**Case #BZA24-000020**  
**Kiawah Island BZA Meeting of November 18, 2024**

**Property Location:** 161 High Dunes Lane

**Request:** Variance request for the reduction of the required 20' side setback for approximately 40 square feet for a proposed single-family residence.

Re: **CONCEPTUAL REVIEW and VARIANCE**  
Construction Address: 161 High Dunes  
ARB Action: Interim Required

### Proposed Site Plan

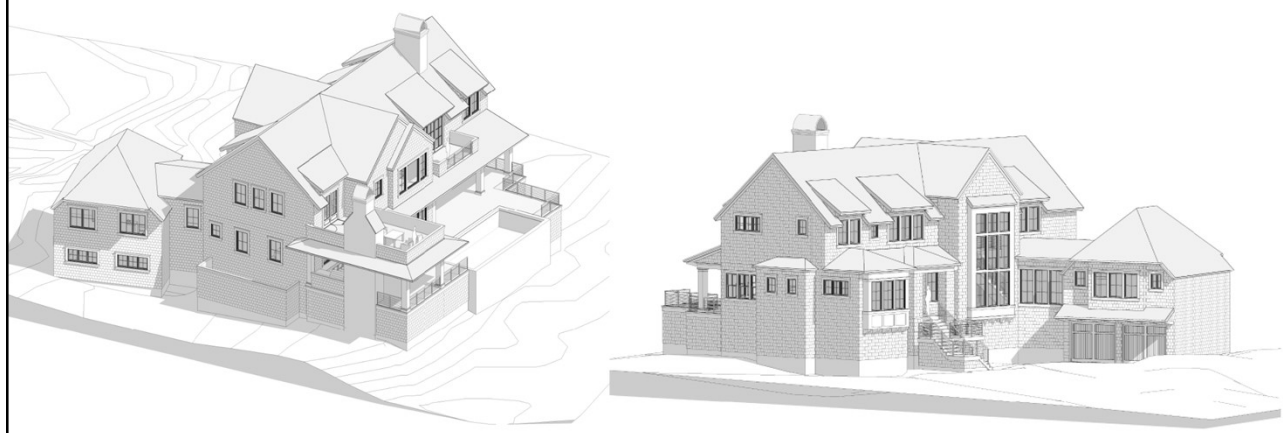
The applicant's proposed plans include a new single-family home with an attached garage. The proposed attached garage encroaches into the side setback by approximately 4 feet 9 inches. The distance from the proposed garage to the property line is approximately 15 feet 3 inches. The total encroachment into the side setback is approximately 40 square feet.

40sq. ft. proposed variance request

1 | 2 LEFT ELEVATION  
 A202 | 1/4" = 1'-0"

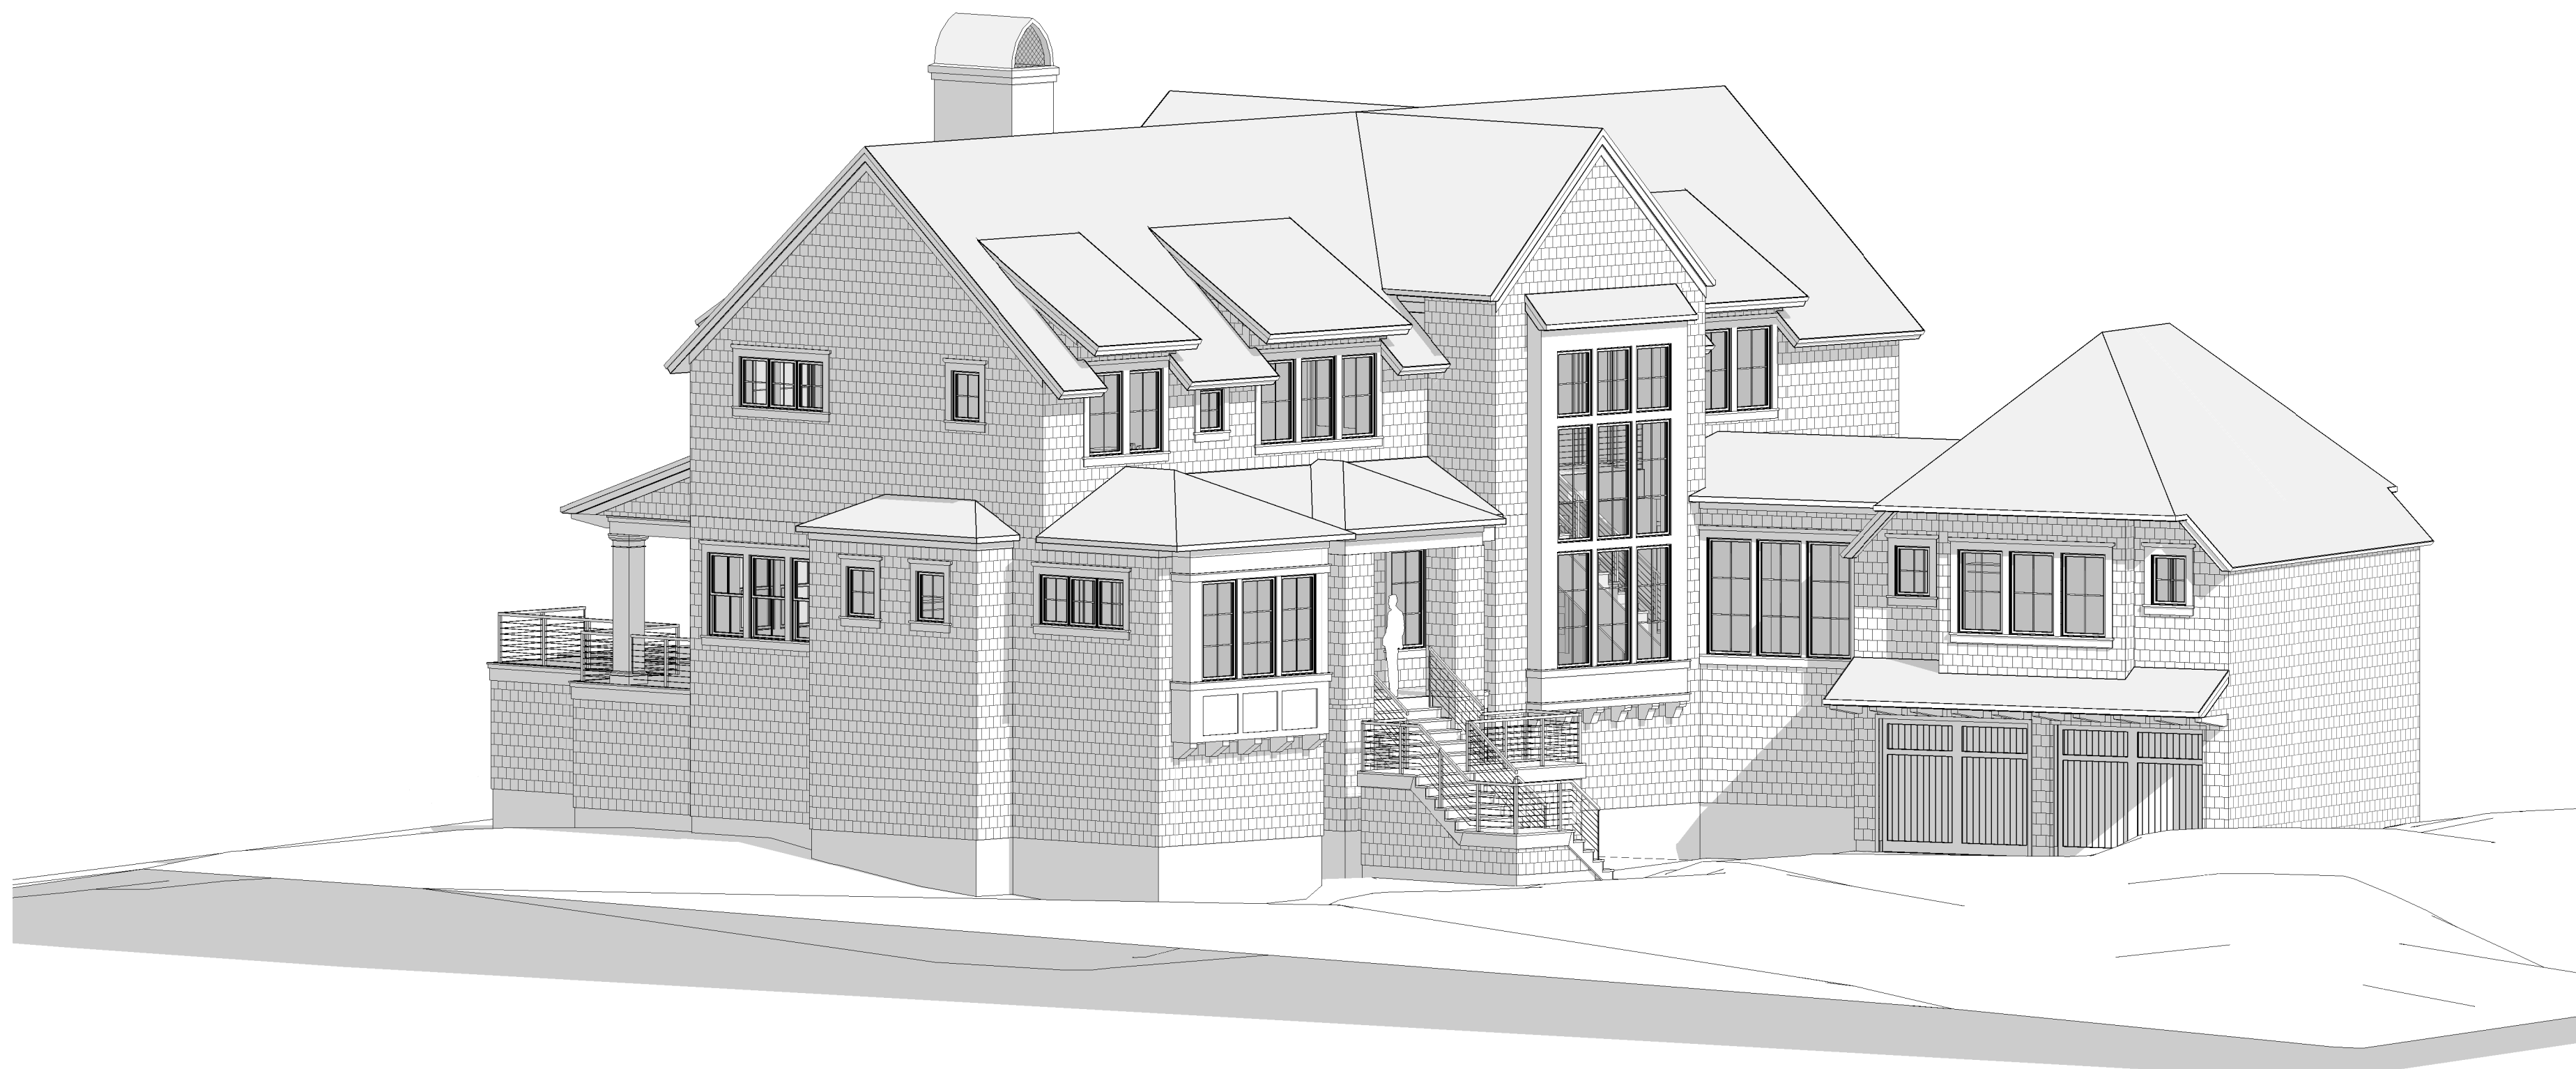
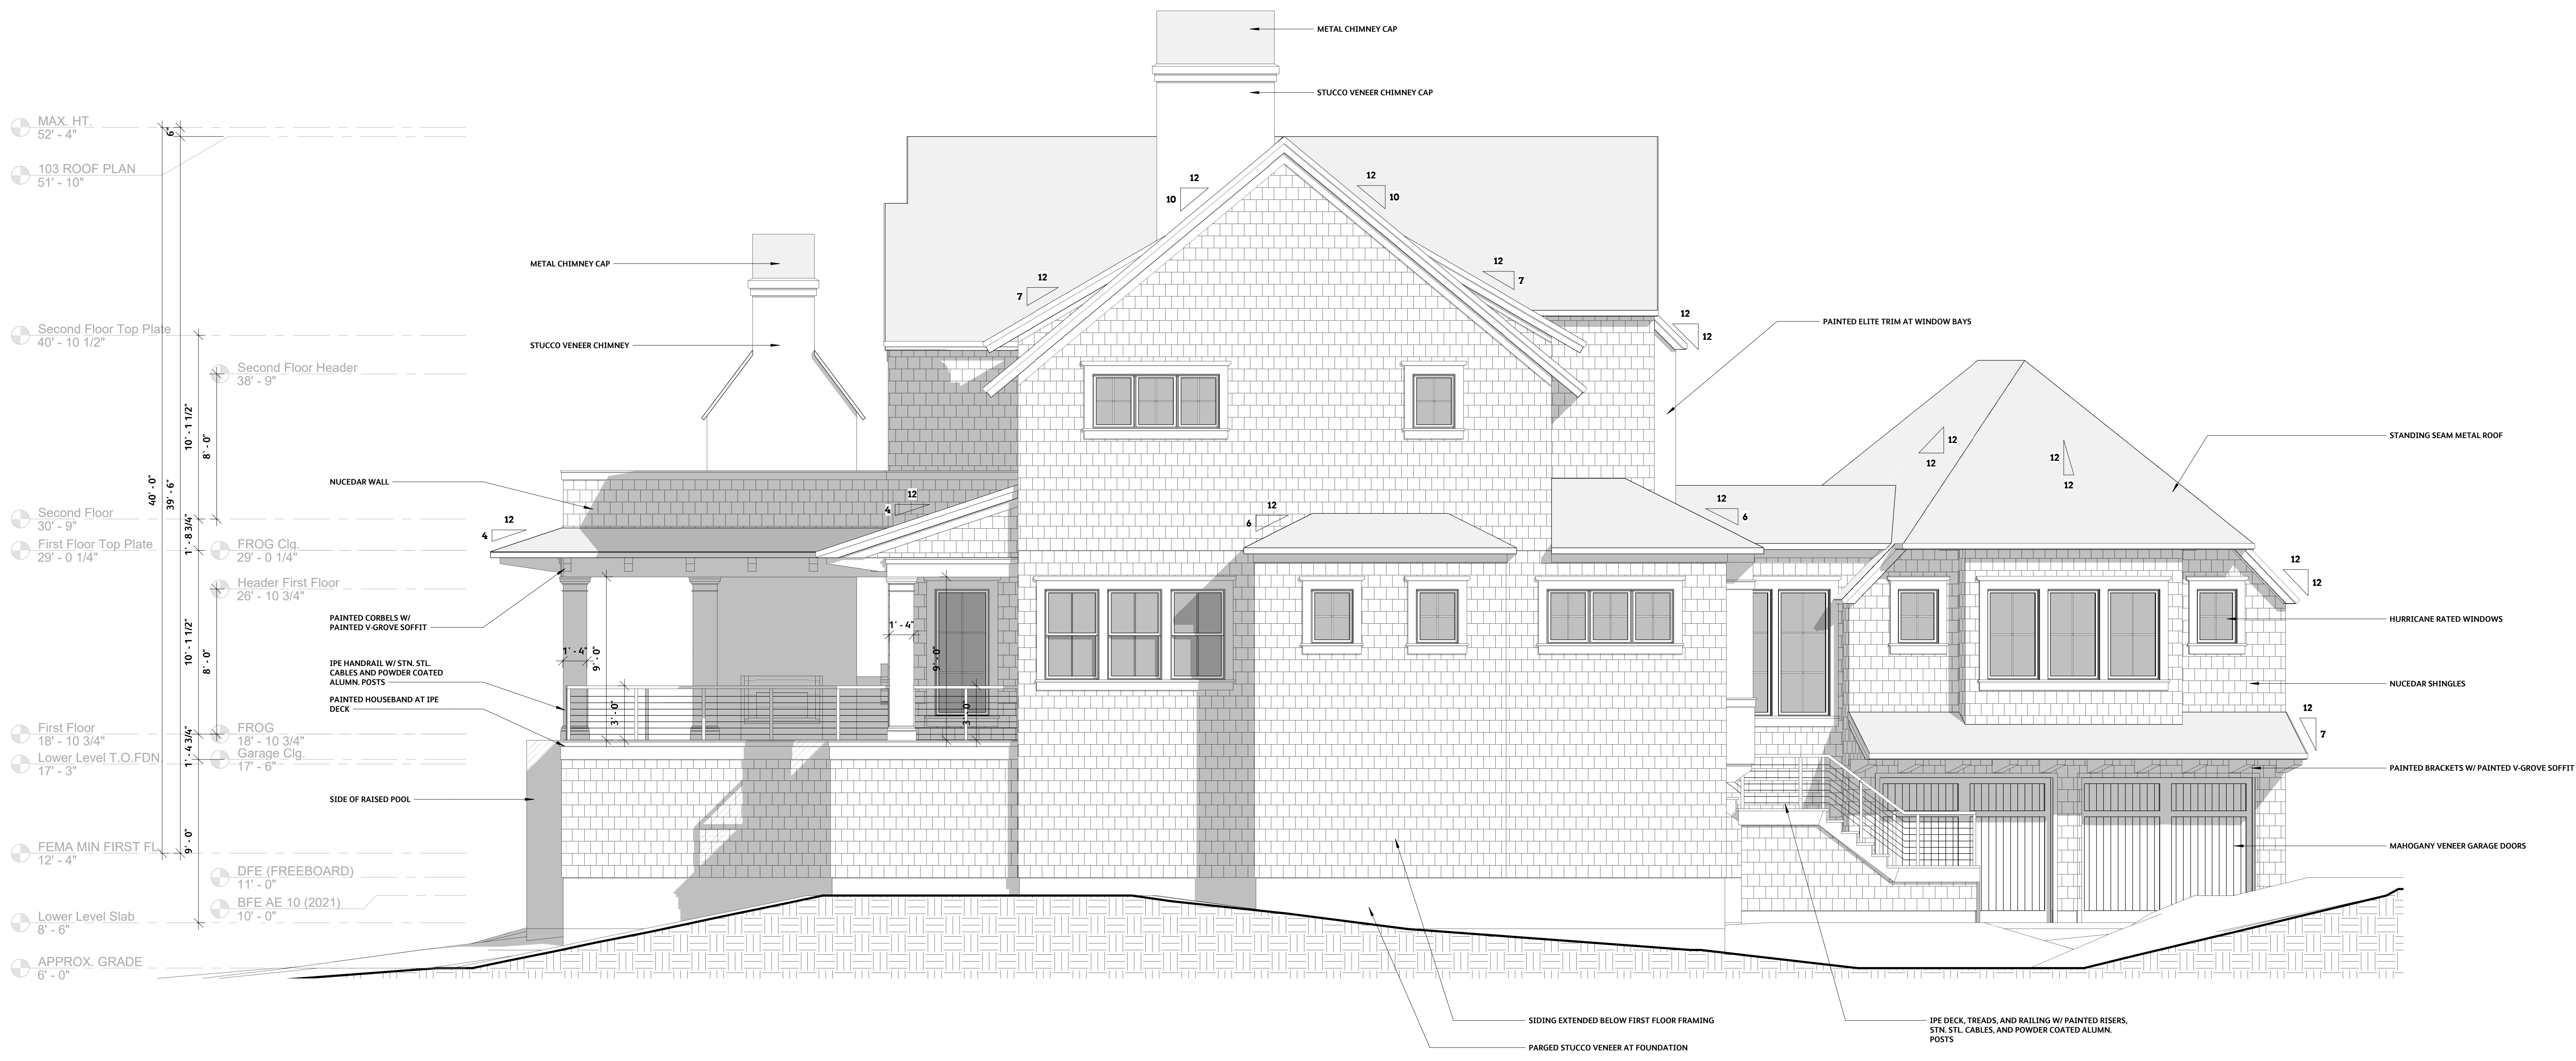
DETAIL OF SIDING BROUGHT BELOW FIRST FLOOR FRAMING TO HELP AESTHETICALLY GROUND THE DESIGN

- A4. Building height should be calculated from TOKI BBHE.
- A5. Please adjust the design of the garage including its roof, complexity, massing and fenestration to be more in keeping with and secondary to the main house. Consider visual mitigation of the tall blank wall facing the street.

- A6. The side gables combined with the nested gables at rear and the stair piece are presenting more two-story expression than is consistent with the second floor within roof requirement. Please study adjustments

#### **36" Live oak on southwest side of lot:**

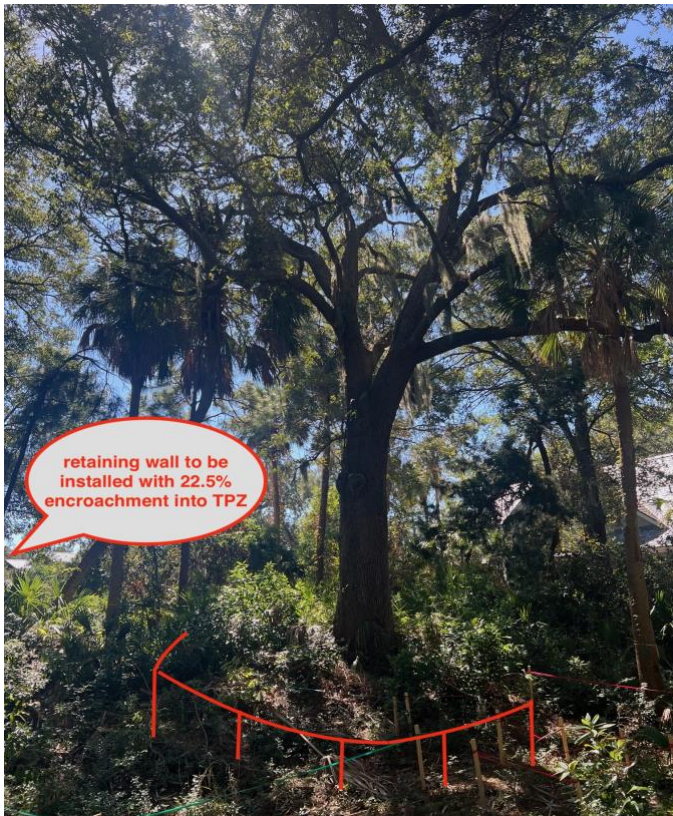
This oak is the dominant oak on the lot. It sits slightly elevated on the backside of a berm. It is currently in good condition and healthy. There is a co-dominant main leader, but this oak is not currently showing any signs of included bark or any structural defects to list. The oaks root system will be slightly encroached on by the driveway, and a retaining wall will need to be installed to allow the roots to be stabilized when the driveway is graded through the berm. The picture below shows the oak and a rough sketch of the location of the proposed retaining wall.

The red lines on the picture to the left are a rough sketch of the location of a proposed retaining wall. This will encroach into the Tree Protection Zone (TPZ) by 22.5%. The threshold for encroachment on grand oak trees is 25%. So, this is a reasonable amount to encroach into the root zone, while still allowing enough roots to not be impacted by construction.

It is highly recommended that this tree be fertilized prior to, during and after construction for some time to replenish beneficial nutrients and allow the tree to replace stored nutrients that will be lost by way of root disruption. This tree should also be sprayed with insecticide along the trunk as a preventative measure to ambrosia beetles.

Fill dirt, should not be added on the inside of this proposed retaining wall as that will compact soils and restrict oxygen to the root zone.

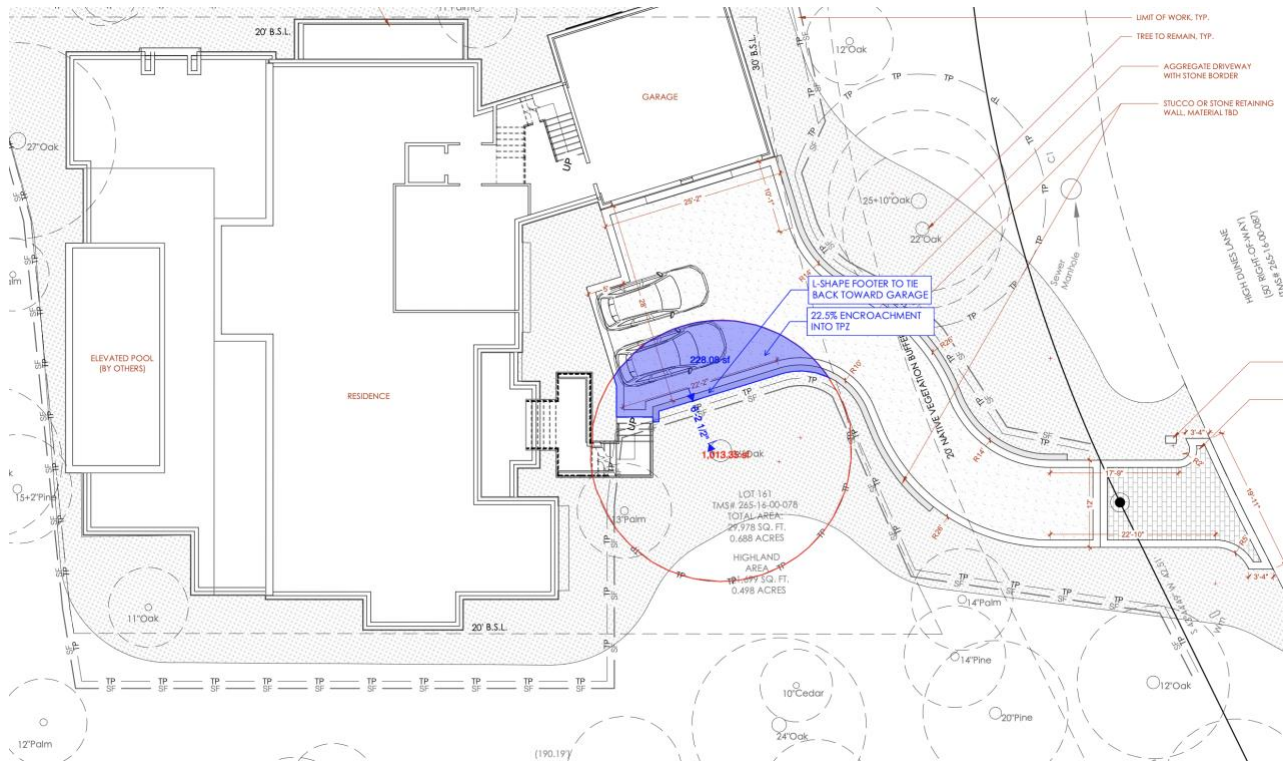
The drawing below shows the shaded area where the encroachment into the rootzone will be located along with the location of the driveway and home. As stated above, the 22.5% encroachment is under the 25% threshold and the tree should survive with proper care and preservation of the remaining roots.
